TR-105 ADSL2/2plus Functionality Test Plan

Issue: 1 Corrigendum 2 Issue Date: May 2011

The document contains corrections to TR-105 Issue 1.

Figure 7-1 REIN Noise for SES test

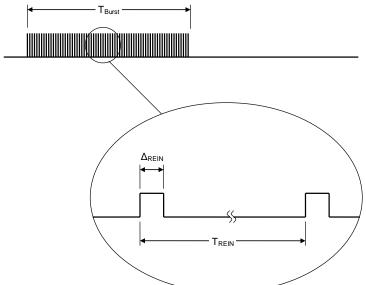
The test SHALL be done with bursts of the repetitive impulse noise (REIN) in addition to the background noise. The REIN noise duration is 690ms (T_{Burst}). The REIN pulse consists of a "Burst of pseudo random AWGN" at a level of –90dBm/Hz differential mode from 138 kHz up to 2.2 MHz, where the out-of-band noise shall not be higher than -140dBm/Hz. The pulse duration Δ_{REIN} depends on the specific test profile. The pulse SHALL be repeated every 10 ms (T_{REIN}).

(5) Force one 330ms "micro interruption" every 1s for 2 seconds (a
	total of 2 micro interruptions). Inject the REIN noise of duration
	T _{Burst} (Figure 7-1) at the ATU-R side of the loop with a pulse
	duration Δ_{REIN} depending on the specific test profile:
